II. Corrections and Additions to the Draft EIR

This section of the Final EIR provides changes to the Draft EIR that have been made to revise, clarify, correct, or add to the environmental impact analysis for LACMA Building for the Permanent Collection (the Project). Such changes are a result of public and agency comments received in response to the Draft EIR and/or new information that has become available since publication of the Draft EIR. The changes described in this section do not result in the Project creating any new or substantially increased significant environmental impacts.

The Applicant has proposed several modifications to the Project as described in the Draft EIR, which are primarily related to the design of the Museum Building. Refinements to the Museum Building include: (1) an overall square footage reduction from approximately 387,500 gross square feet to approximately 347,500 gross square feet; (2) a shift of the portion of the Museum Building crossing Wilshire Boulevard approximately 30 feet to the east; (3) a change in the geometry of the Pavilions to the Museum Building from polygonal to rectilinear forms and an alteration to the curvilinear geometry on the e

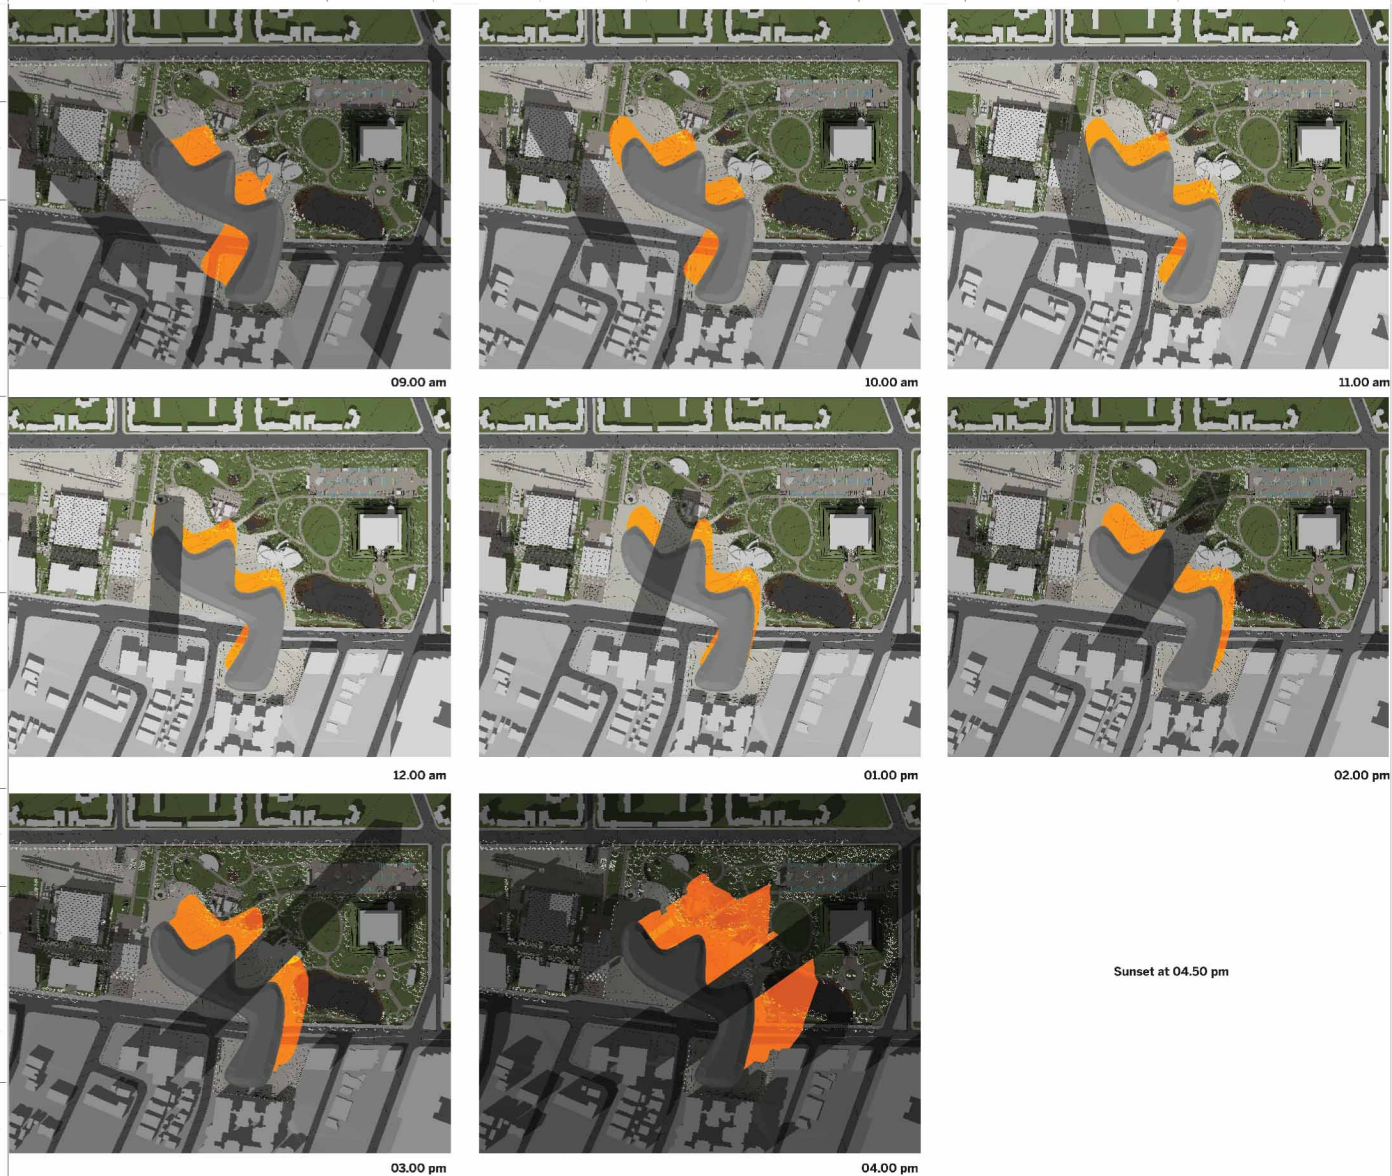
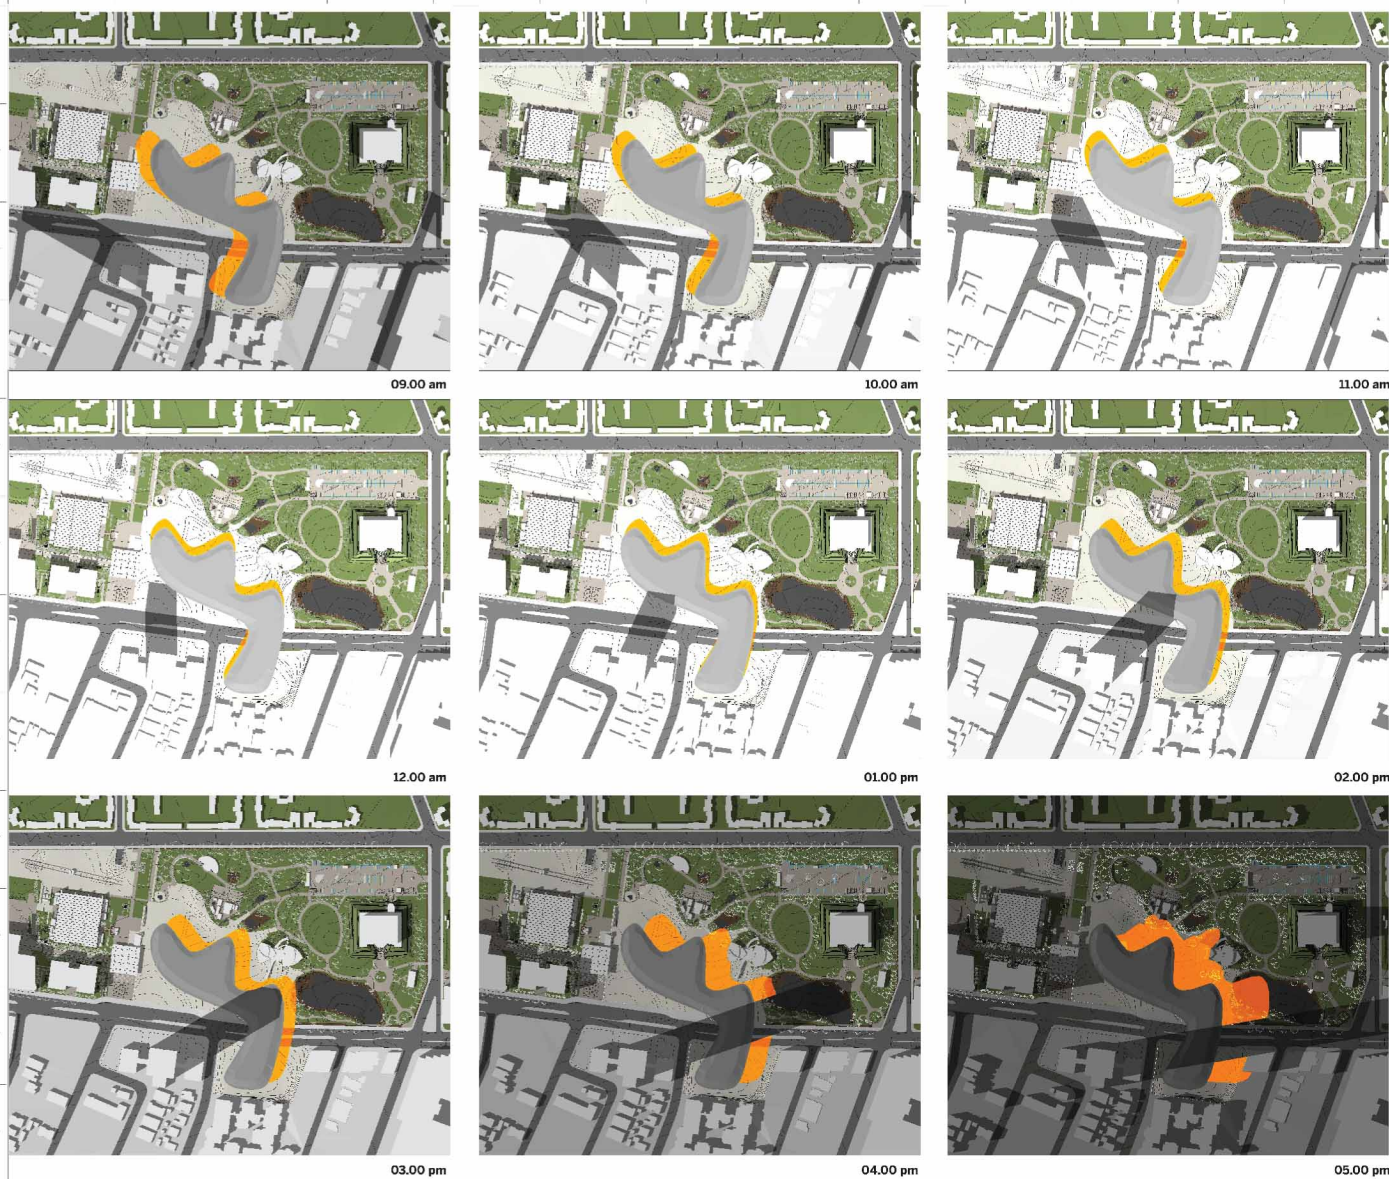
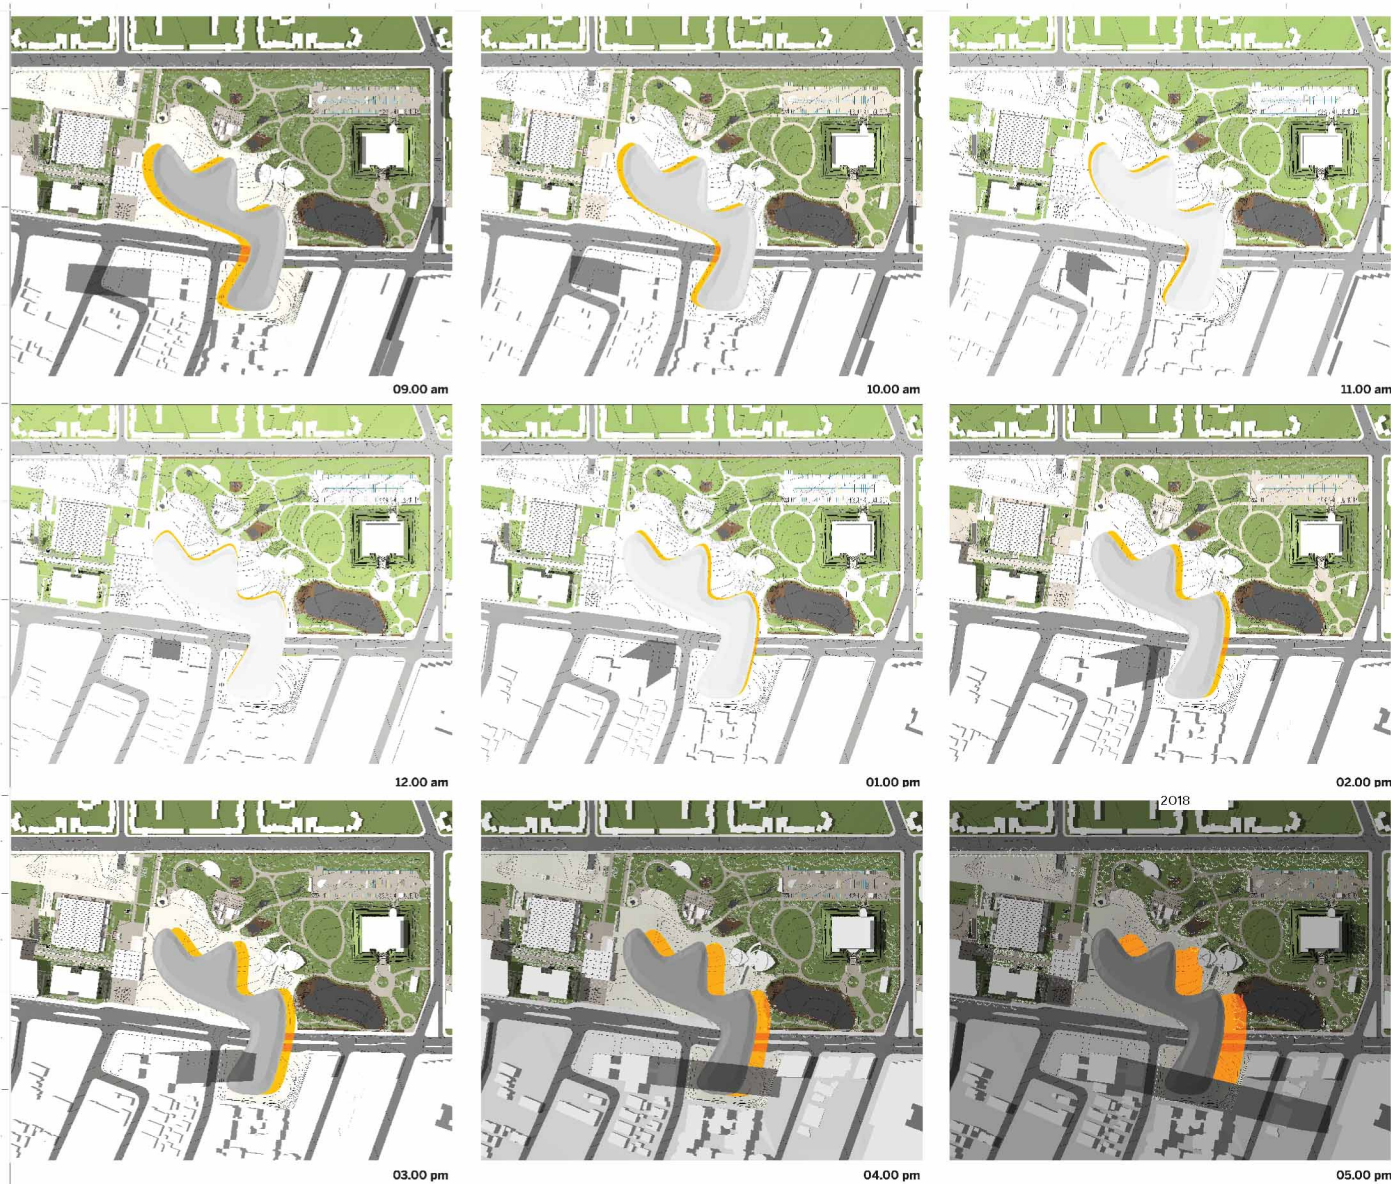
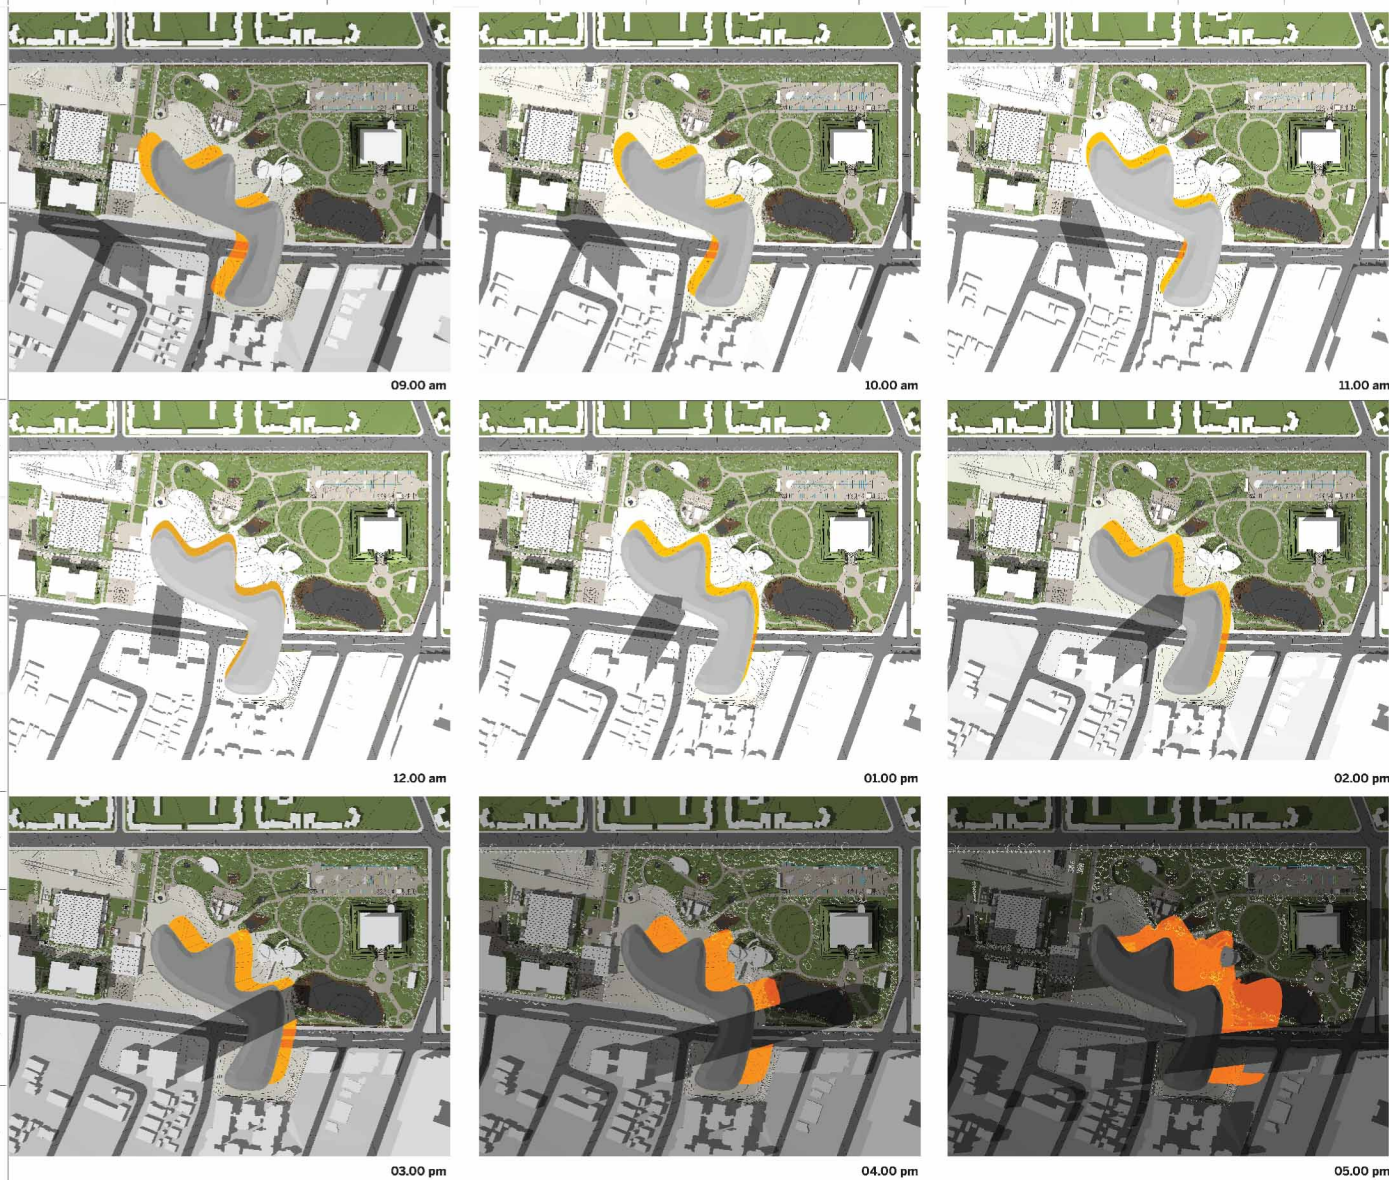
Volume 1, Section IV.A, Aesthetics, Views, Light/Glare, and Shading, pages IV.A-71 through IV.A-74, replace Figures IV.A-15 through IV.A-18 with Revised Figure IV.A-15 through Revised Figure IV.A-18, on pages II-42 through II-45.
